Project	<b>IEEE 802.16 Broadband Wireless Access Working Group</b> < <a href="http://ieee802.org/16">http://ieee802.org/16</a> >	
Title	<b>Supplemental material for Tgd comments</b>	
Date Submitted	<b>2004-04-28</b>	
Source(s)	Itzik Kitroser Yossi Segal Yigal Leiba Zion Hadad Runcom Technologies Ltd. 2 Hachoma St. 75655 Rishon Lezion, Israel	Voice: +972-3-9528440 Fax: +972-3-9528805 <a href="mailto:itzikk@runcom.co.il">mailto:itzikk@runcom.co.il</a> <a href="mailto:yossis@runcom.co.il">mailto:yossis@runcom.co.il</a> <a href="mailto:yigall@runcom.co.il">mailto:yigall@runcom.co.il</a> <a href="mailto:zionh@runcom.co.il">mailto:zionh@runcom.co.il</a>
Re:	802.16-REVd Sponsor ballot recirc	
Abstract	This document contains supplemental material for 802.16-REVd sponsor ballot	
Purpose	Adopt suggested changes into P802.16-REVd/D4 draft	
Notice	This document has been prepared to assist IEEE 802.16. It is offered as a basis for discussion and is not binding on the contributing individual(s) or organization(s). The material in this document is subject to change in form and content after further study. The contributor(s) reserve(s) the right to add, amend or withdraw material contained herein.

**Figure 209—Example of the data region which defines the OFDMA allocation**

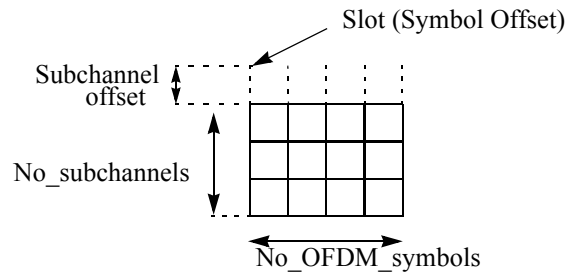
Comment #257. The current OFDMA PHY contain usage of concepts as Zone and a Segment which are not clearly defined anywhere. A clear definition of the terms is required for a consistency reasons. In addition the OFDMA data mapping refers to FEC block, while the correct term is OFDMA slot.

A slot in the OFDMA PHY requires both a time and subchannel dimension for completeness (subchannels are defined in 8.4.6.). An OFDMA slot is one subchannel by ~~two~~one OFDMA symbol.

In OFDMA, a Data Region is a two-dimensional allocation of a group of contiguous subchannels, in a group of contiguous OFDMA symbols. This allocation may be visualized as a rectangle, such as the 4x3 rectangle shown in Figure 209.

Figure 210—Example of mapping ~~FEC blocks~~OFDMA slots to subchannels and symbols in the uplink

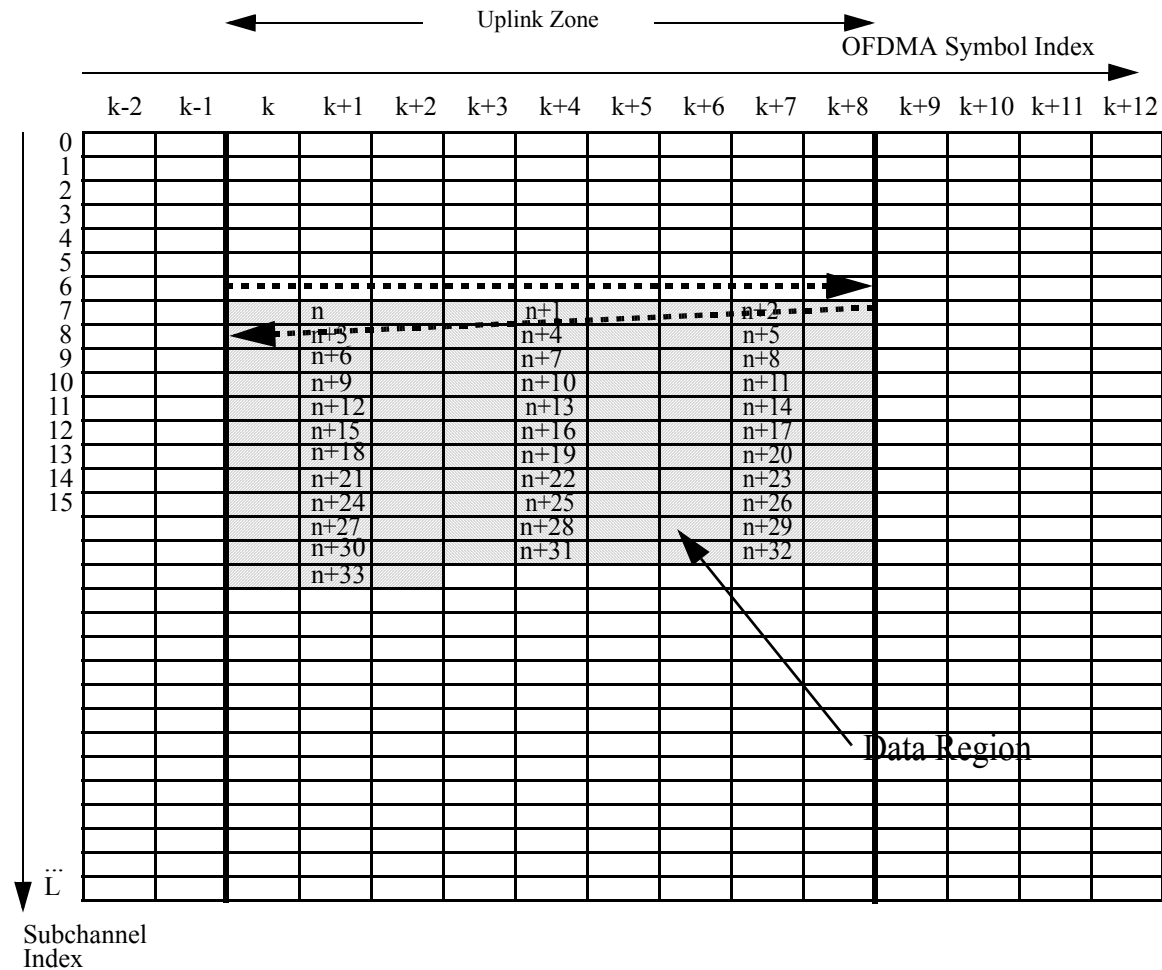
Figure 210 and Figure 211 illustrates the order in which ~~FEC blocks~~OFDMA slots are mapped to subchannels and OFDMA symbols.

[replace figure 210 with the following figure]

Figure 213—Time plan - one TDD time frame (with only mandatory zone)

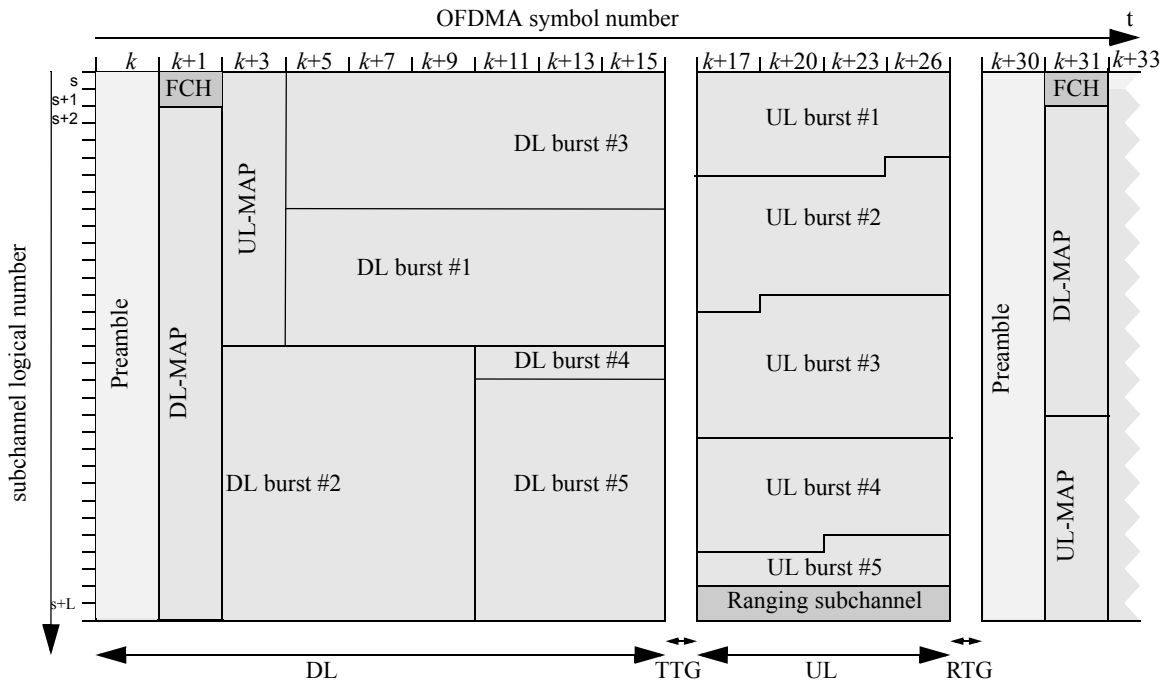
Comment #350 changed the UL allocating scheme to a uni-dimensional scheme. This means that the UL allocations are no longer rectangles, this should be reflected in figure 213. In addition figure 213 does not provide a clear example of the OFDMA frame with multiple zones.

[Page 468, line 5, section 8.4.4.2, change figure 213 (and title) as follows:]

**Figure 215—FCH subchannel allocation for all 3 segments**

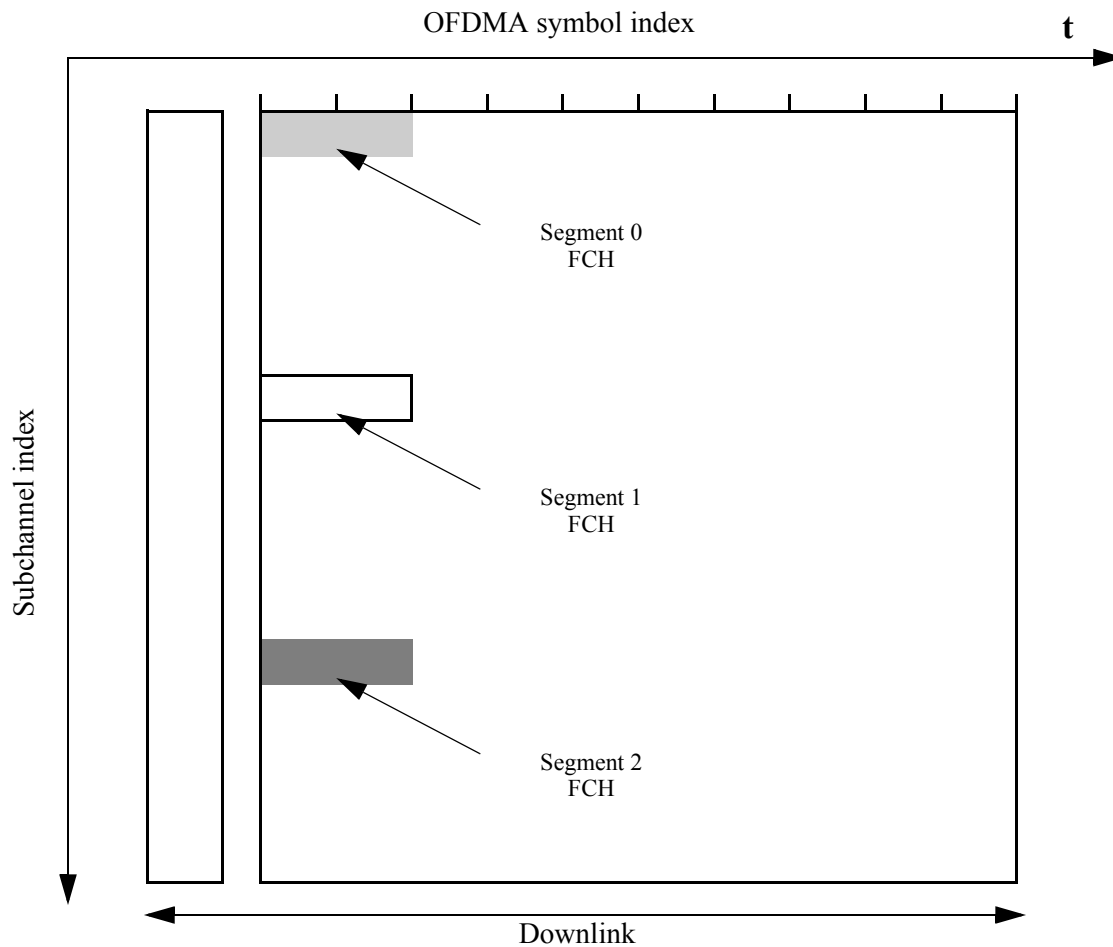
In addition, figure 215 describes the FCH as transmitted over one OFDMA symbol and two subchannels, and should be two OFDMA symbols over one subchannel.

**[Page 471, line 4, section 8.4.4.5, replace figure 215 with the following figure]**

Figure 216—Example of renumbering the allocated subchannels for segment 1 in PUSC

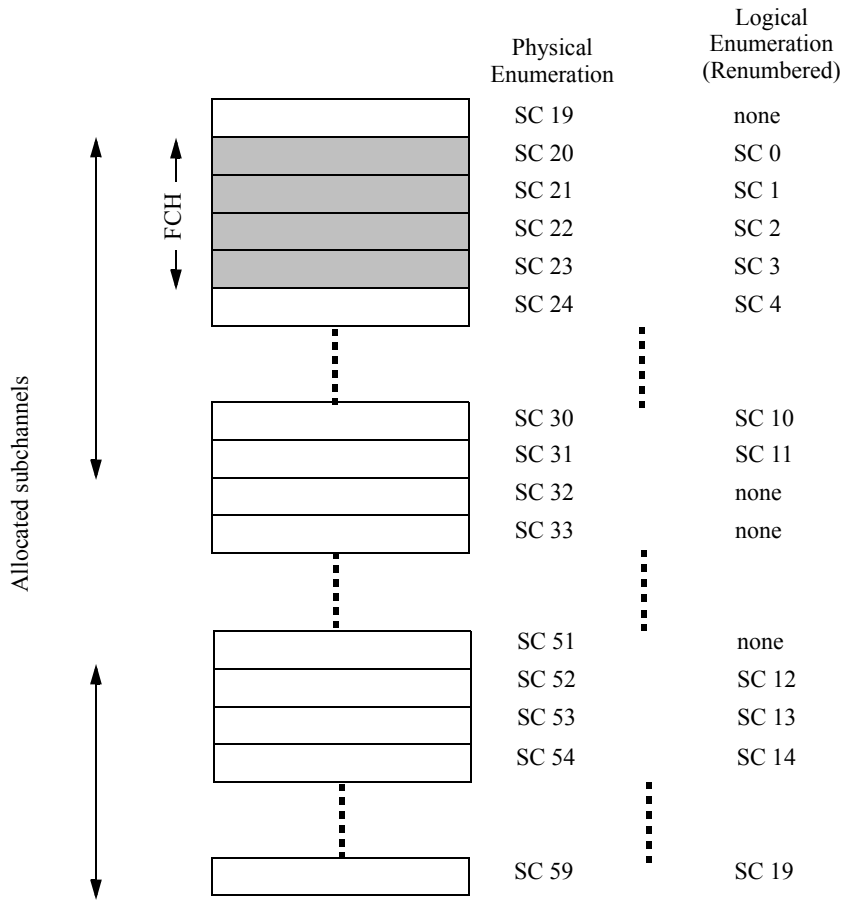
The example given in figure 216 is wrong, since the standard defines that the FCH is transmitted using a duration of 4 OFDMA subchannels.

**[Page 472, line 2, section 8.4.4.5, Change figure 216]**

Figure 217—Example of UL renumbering the allocated subchannels for a segment in PUSC

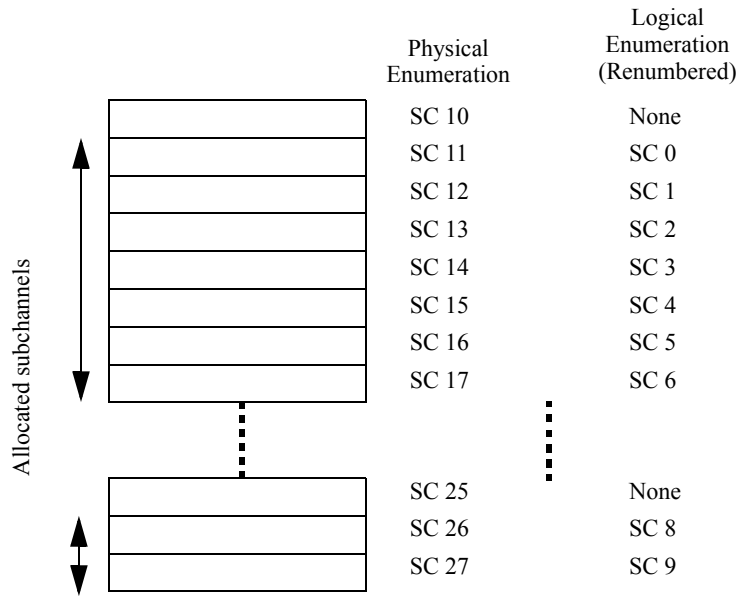
The current subchannels renumbering definition for the UL stating that "no renumbering is done" is wrong, since obviously a renumbering scheme is required.

[Page 472, line 2, section 8.4.4.5, Insert new figure 217]

Figure 235— STC usage with OFDMA for FUSC

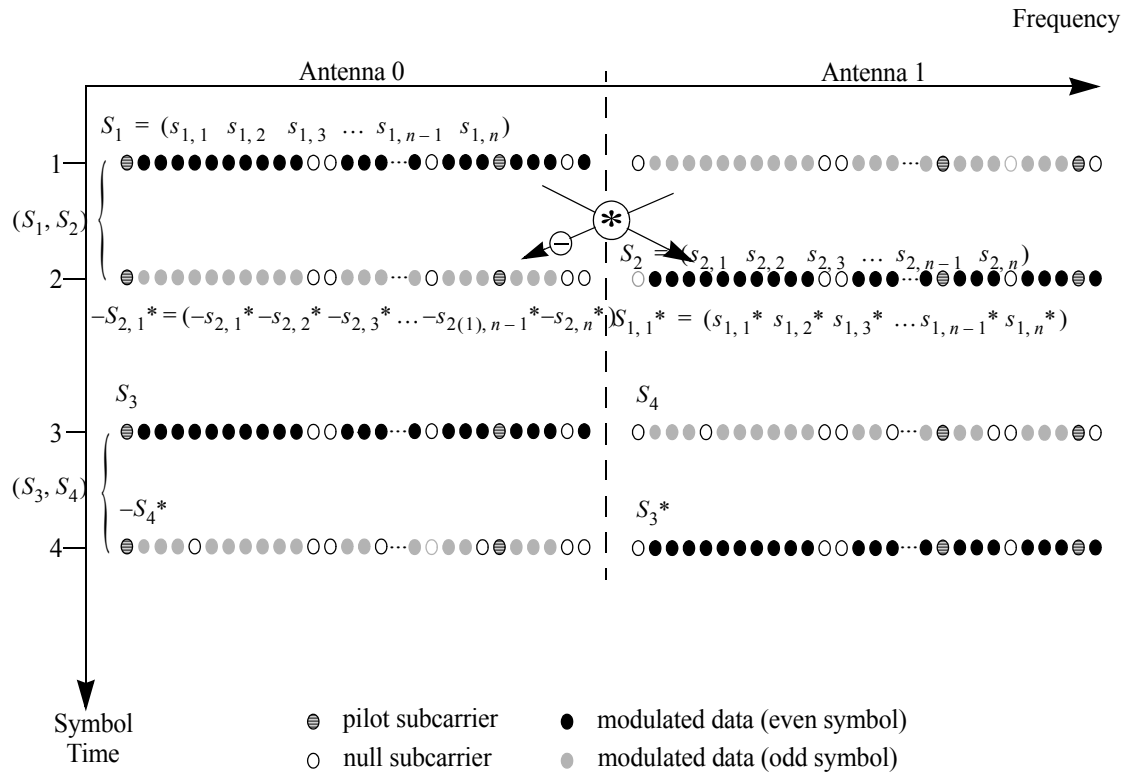
Comment #362 contained instruction to change figure 235, this comment wasn't implemented due to an unclear instruction, this comment provide the required changes. In addition, the existing figure is relevant for FUSC only, an additional figure is required for the PUSC case.

[Page 519, line 3, section 8.4.8.2.1, change figure 235 as indicated, change title to make figure relevant to FUSC]
